LR-N16-0148

Hope Creek Generating Station
Renewed Facility Operating License No. NPF-57
NRC Docket No. 50-354

Subject: Supplemental Information Regarding Hope Creek Generating Station's
Request for Relaxation from the Hardened Containment Vent Release
Point Height Requirement of NRC Order EA-13-109

**Supplemental Information Regarding Hope Creek Generating Station's Request
for Relaxation from the Hardened Containment Vent Release Point Height
Requirement of NRC Order EA-13-109**

Figure 1: Option 1, 283'-5" HCVS Modifications

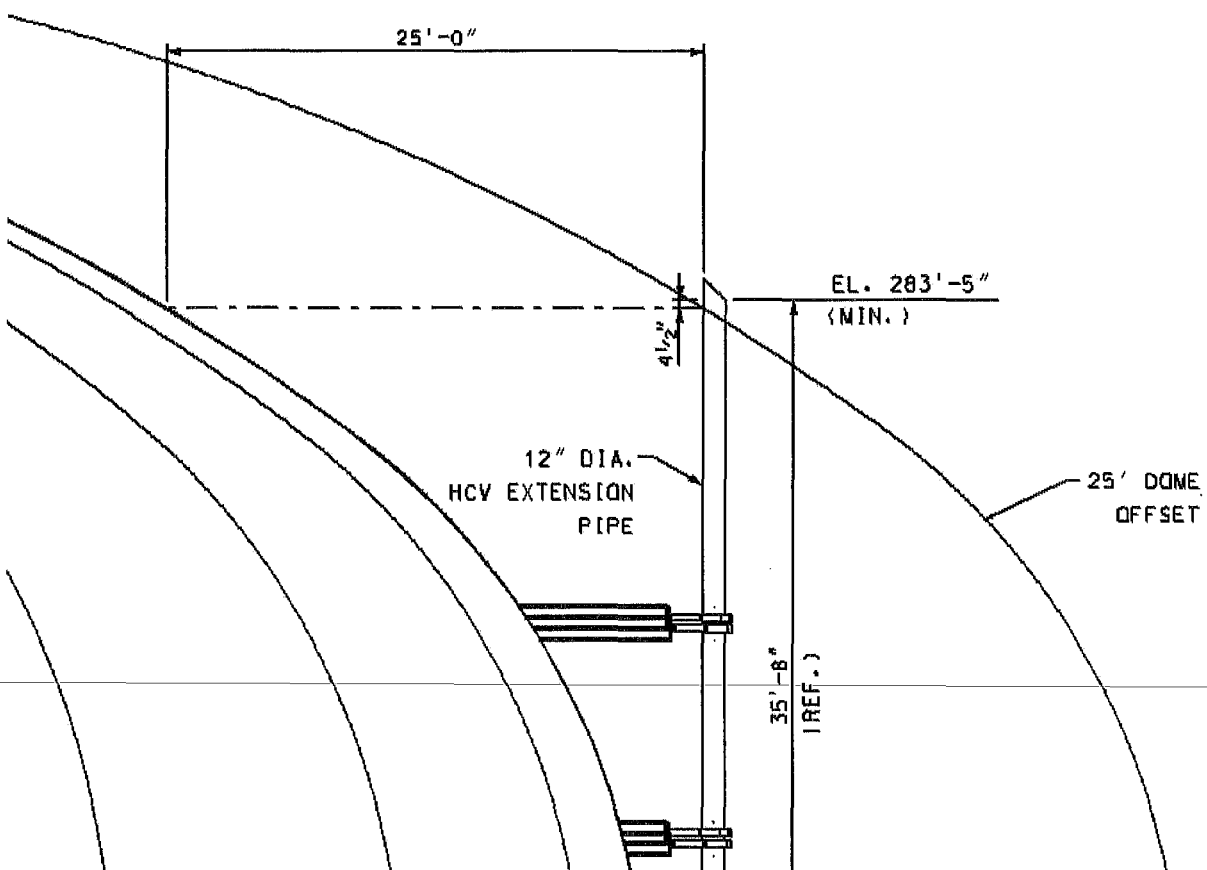
4.1 Option 1 Extend the current HCVS to elevation 283'-5" via straight vertical extension

This option would not achieve verbatim compliance with the vent height requirement of NRC Order EA-13-109, and it would still require NRC relaxation. This option meets the 25'-0" lateral separation distance recommended by HCVS-FAQ-04 in Appendix J to NEI 13-02, Revision 1.

This option has been proven to have the capability to meet the 1% RCTP decay heat removal requirement. However, it is not a preferred option because it would result in negligible benefit in atmospheric dispersion and would not result in full compliance with NRC Order EA-13-109.

Extending the vent height vertically from elevation 250' to elevation 283'-5" would involve extensive modifications in regards to pipe supports and anchors into the Reactor Building, as shown in Figure 1. This option also involves installation challenges and personnel safety considerations due to working at heights and heavy load handling.
